## Leo's questions on $\pi^0 \rightarrow \mu e$

### Leo's questions on $K \rightarrow \pi^0\pi^0\mu e$

Leo’s questions on  $K \rightarrow \pi^0 \mu e$

### **Taku’s questions on $K \rightarrow \pi^0 \mu e$**

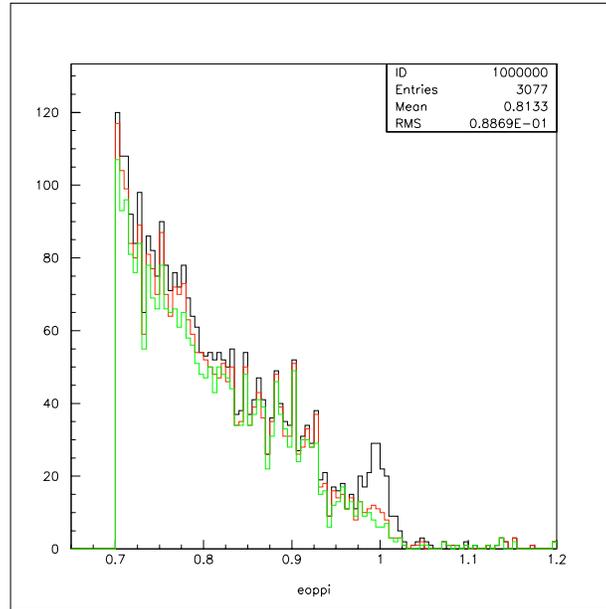
T1. Why is the pi/e rejection factor so high for the CsI? The MC pion shape is not reliable close to 1.

The pi/e rejection factor was determined solely from ke3 events from trigger 2. I looked at this again and still think that value is right given the tight cuts Angela made (although the exact number is not important for the argument I was making). If I take 2-track events with a few standard clean-up cuts (vertex chisquared, track matching in the magnet), then require one track to have an E/p between .95 and 1.05, the other track should be a pion, since these should be mostly ke3 events. Using just these cuts I get a pi/e rejection of about 290. But if I make the additional requirement of a loose TRD cut on the electron, to be sure it is an electron, I get a pi/e rejection of 470. Adding in a fusion  $\chi^2$  cut on the pion track increases the rejection factor to 550. Making harder E/p and fusion  $\chi^2$  cuts on the pion increases the rejection to more than 800.

The figure below shows why the rejection factor for the pion changes when I make a TRD cut on the electron. The black curve is the E/p distribution for the track labeled as a pion when there is an E/p cut of 0.95 to 1.05 on the other track. There is clearly a little peak at E/p=1, indicating that some of these tracks are really electrons. The red curve is the same, but also making a loose TRD cut on the electron (probe<0.05). The green curve has no cut on the TRD information for the electron track, but instead it has a loose anti-electron TRD cut (probpi >0.1).

So I think these numbers are fair, but as I have already noted the exact values of the rejection factors is not important.

Figure 2:  $M_{\gamma}$  and  $p_t^2$  distributions for data and ke3 Monte Carlo.

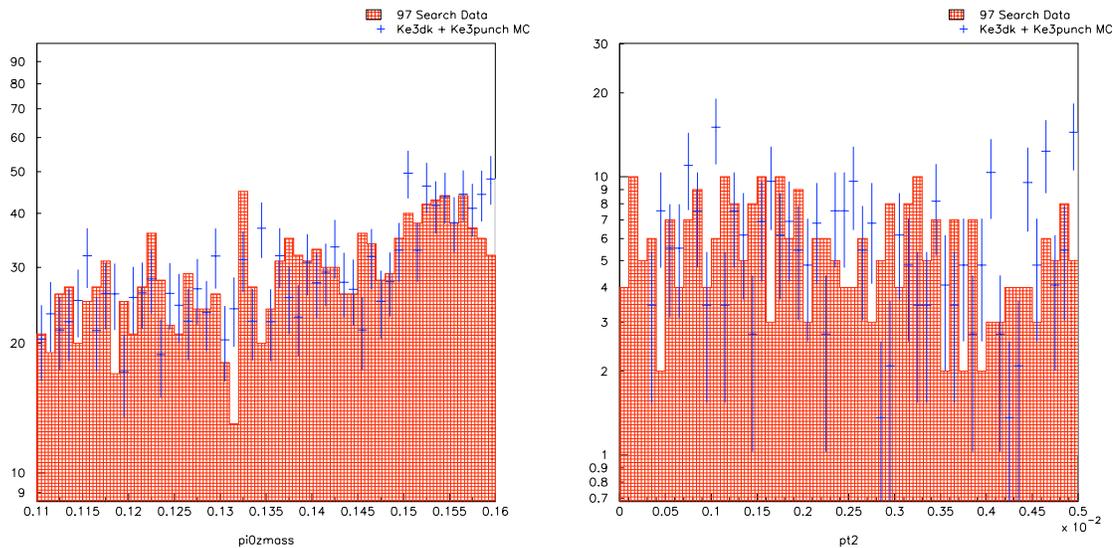
T2. “For Ke3 background events, is there a way to estimate the background level using MC?”

Angela did a 1x flux ke3 Monte Carlo by doing forced decay and punch through. but that was before the pi-mu decay bug was found. The ke3 MC does have a flat distribution for both  $M_{\gamma\gamma}$  and  $p_t^2$  distribution as was seen in the data. See the two figures below, which are from Angela’s thesis.
